**DEPARTMENT OF PLANNING AND COMMUNITY  
DEVELOPMENT STAFF REPORT**

<b>PLANNING COMMISSION AGENDA ITEM # 4:</b>		
<b>Project Name:</b>	<b>Rollingstone Village #DPF-09-01</b>	
<b>Prepared By:</b>	Jonathan Spence, Senior Planner (Ext. 224) Alexis Casale, Historic Preservation Planner, (Ext. 202)	
<b>Through:</b>	John Eastman AICP, Planning Services Manager (Ext. 275)	
<b>Planning Commission (PC):</b>	February 26, 2009	
<b>City Council (CC):</b>	March 17, 2009	
<b>Zoning:</b>	Community Commercial (CC)	
<b>Applicant:</b>	Rollingstone Development Corp C/O Brian Bavosi, P.O. Box 774842, Steamboat Springs, CO 80477, 970-871-0056	
<b>Request:</b>	Concurrent Development Plan/Final Development Plan for a mixed use development on a 2.79 acre site totaling 100,687 square feet including 70,849 square feet of residential space and approximately 22,000 square feet of commercial and amenity space. The project proposes variances to the required thirty (30) foot side setback (10' feet proposed) and the maximum Floor Area Ratio of 50% (83% proposed). A conditional use is required for the residential units along the pedestrian frontage.

SHEET NO.  
**DPF2.1**

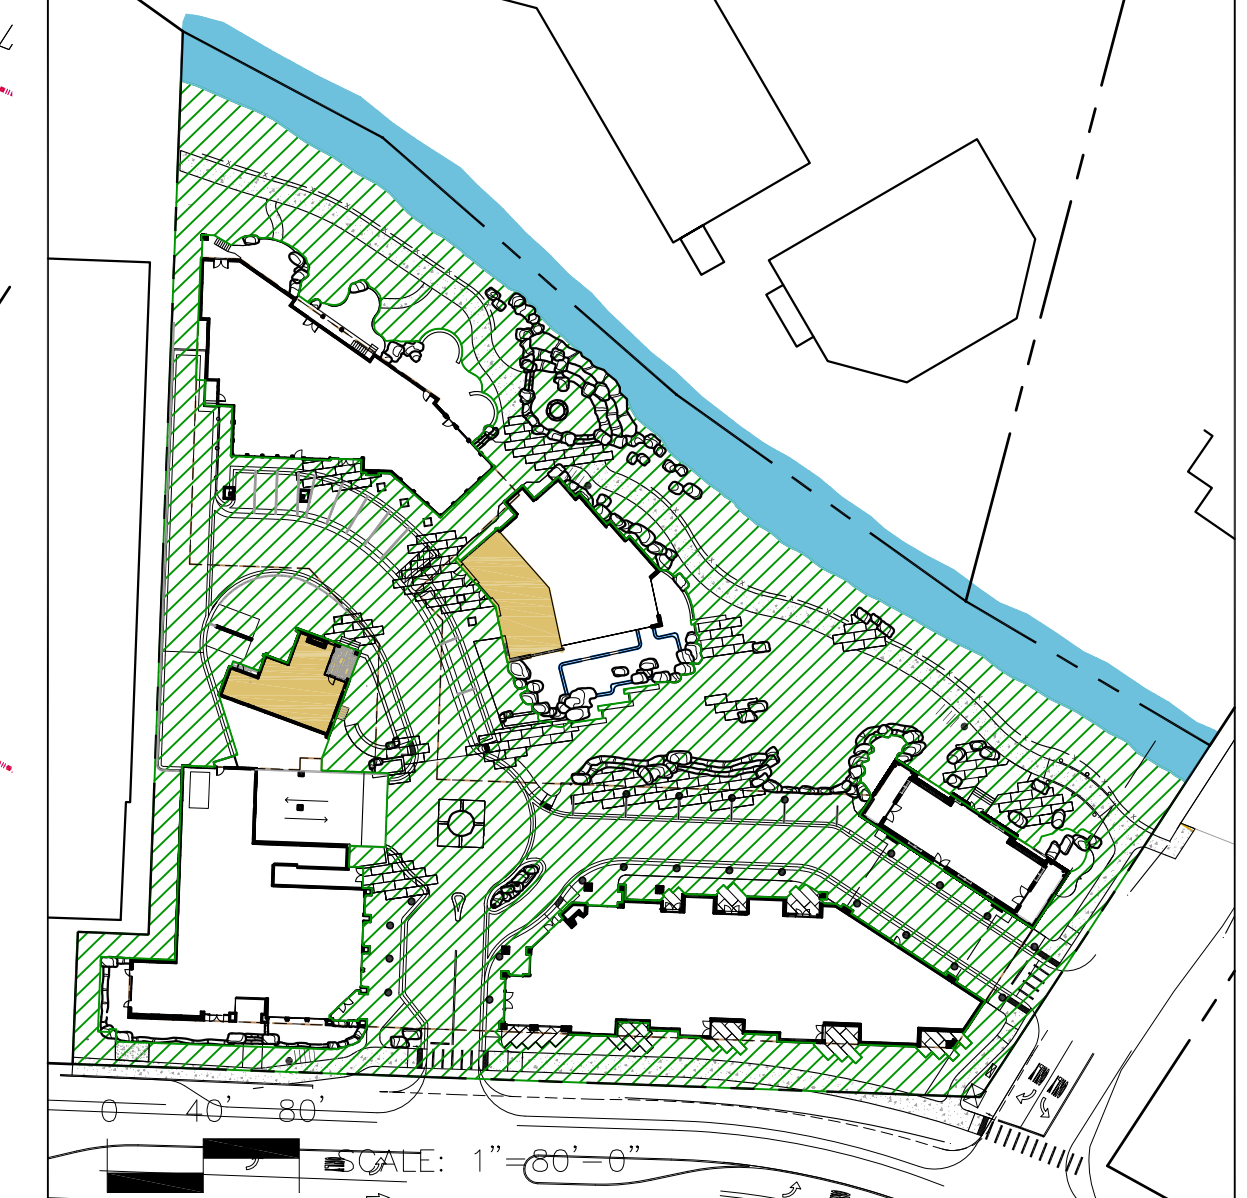
7. The sidewalk in front of Building A will be detached per Public Works standards if a bus shelter is not included in the Building Permit submittal.
8. At time of first final condominium or townhome plat, the applicant must dedicate a public access easement as depicted on the inset diagram on Sheet DPF2.1 of the plan set.
